- 1 LDA2021/0122**
14 Ryedale Road, Denistone (proposed Lot 14)

Construction of part 1 and 2 storey boarding house with 8 boarding rooms for 16 lodgers and 4 parking spaces.

City of Ryde Local Planning Panel Report

Figure 9: Proposed ground floor plan

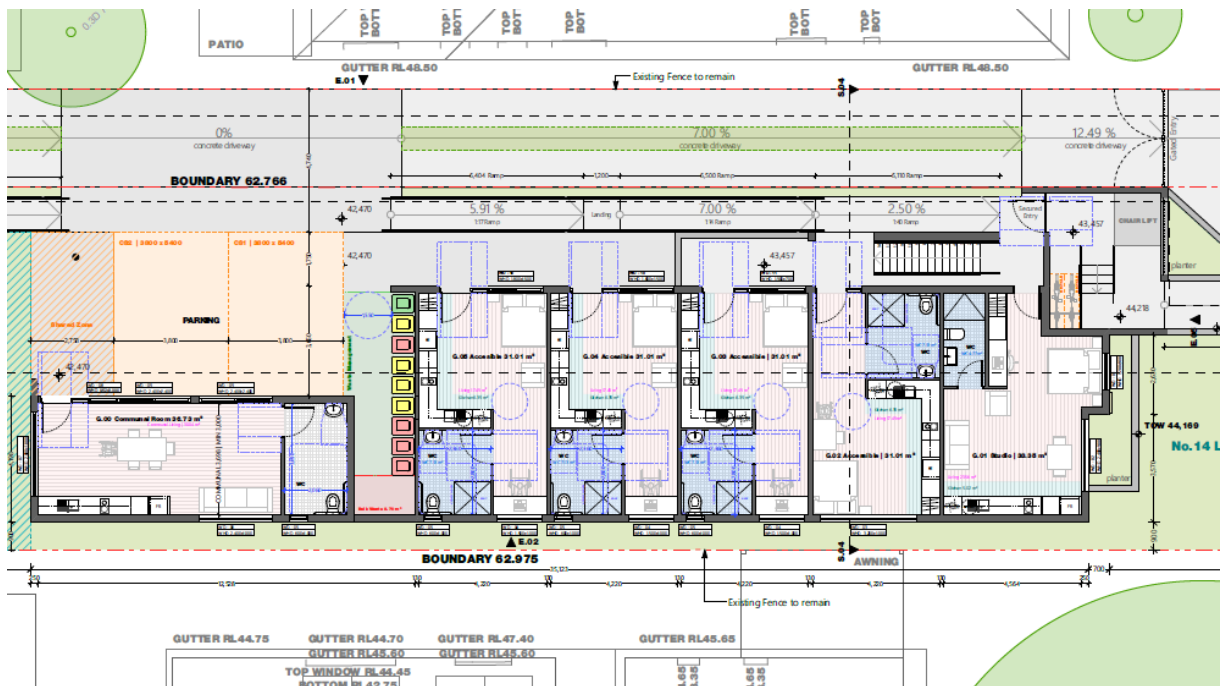
that the 2 parking spaces adjacent to the common room have widths of 3.8m, due to the narrow width of the access handle, in order to allow maneuverability from the narrow access handle.

The plans do not indicate the provision of any fencing to the side boundaries of the site but show a 1.8m high privacy screen adjacent to the car parking space at the rear boundary, with the remainder of the rear boundary being unfenced. No front fence is proposed, however a 2.3m high metal security fence “encloses” the front of a 2.76m high projecting front roofed “porch”, which is enclosed by walls to both sides and the rear. The ground floor has a front setback of 10.6m – 11.3m, with the roofed “porch” having a setback of 8.7m. The southern side wall of the building has a length of 35.1m and a side setback of 900mm. The northern side wall has a variable setback from the access handle of proposed Lot 14A of 3.25m – 6.9m. The rear setback proposed is 16.5m.

Figure 1: Proposed Site Plan & Tree Protection Plan (Source: The Ents Tree Consultancy Arborist Report, 2019)

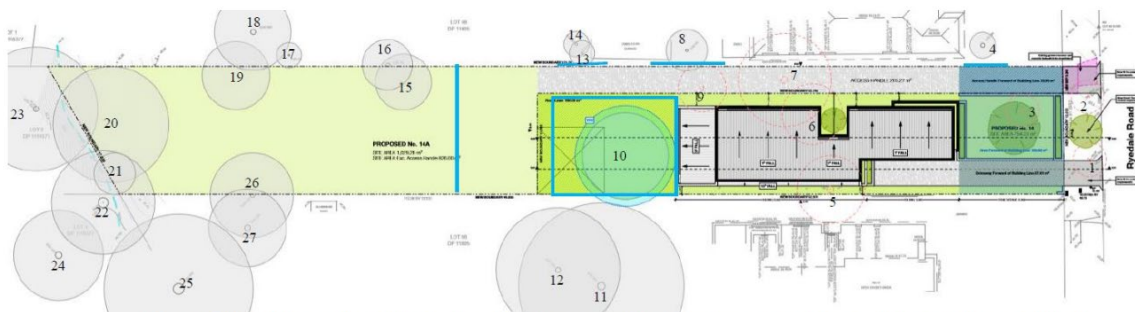
The Arborist Impact Assessment (AIA) submitted as part of this Development Application is considered out of date, being produced on the 18th September 2019 (more than 12 months ago).

The submitted AIA also references and relies upon architectural plans that relate to a different building footprint and design when compared to the architectural plans submitted as part of the development application for the subject site, LDA2021/0122 - (refer to Figure 1 below which indicates different proposed building footprint and inclusion of double driveways).

Inaccurate Assessment of Impacts *The building works and proposed development design referenced in the Arboricultural Impact Assessment prepared by the The Ents Tree Consultancy dated 18th September 2019 do not relate to the architectural plans and design submitted. To enable a full assessment of the proposal to be carried out, a revised Arboricultural Impact Assessment prepared in accordance with the City of Ryde Tree Management Technical Manual must be submitted to Council which relates to the current proposed building design, landscape arrangements, stormwater design and driveway footprints.*

Figure depicting a reverse in manoeuvre and then forward exit.

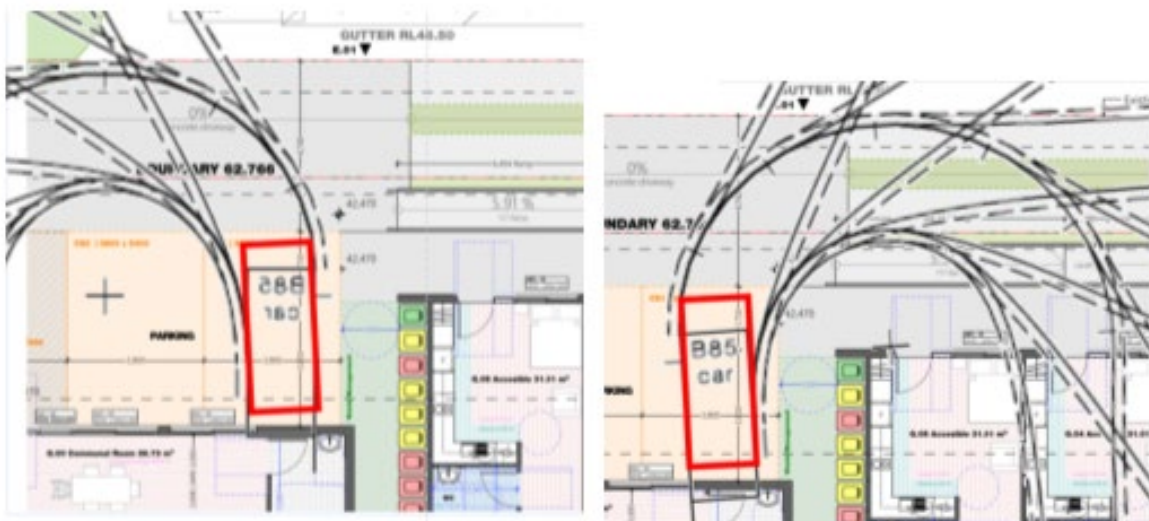
- *The driveway has provided an overtaking bay at the entry to facilitate two-way vehicle movements at the intersection with the road frontage. This is as per the original subdivision and is acceptable.*
- *The access aisle fronting CS1 & CS2 is nominated as 4.74m wide and is less than the minimum required by AS 2890.1 for open parking areas. The applicant has not provided any swept path analysis however an inspection with AS 2890.1 turn templates notes that the spaces appear viable with drivers being able to reverse in and exit in a forward manner. This ideally should be clarified by the applicant. See figure below.*

- *It is evident that vehicles accessing spaces on the subject lot will be to traverse the alternate lot and therefore will require the registration of a ROW over the access paths. This has not been proposed in the approved plans of LDA2019/100 and will therefore need to be addressed, potentially by a condition of deferred commencement.*

Comment: The above concerns are included in reasons for refusal of the application.
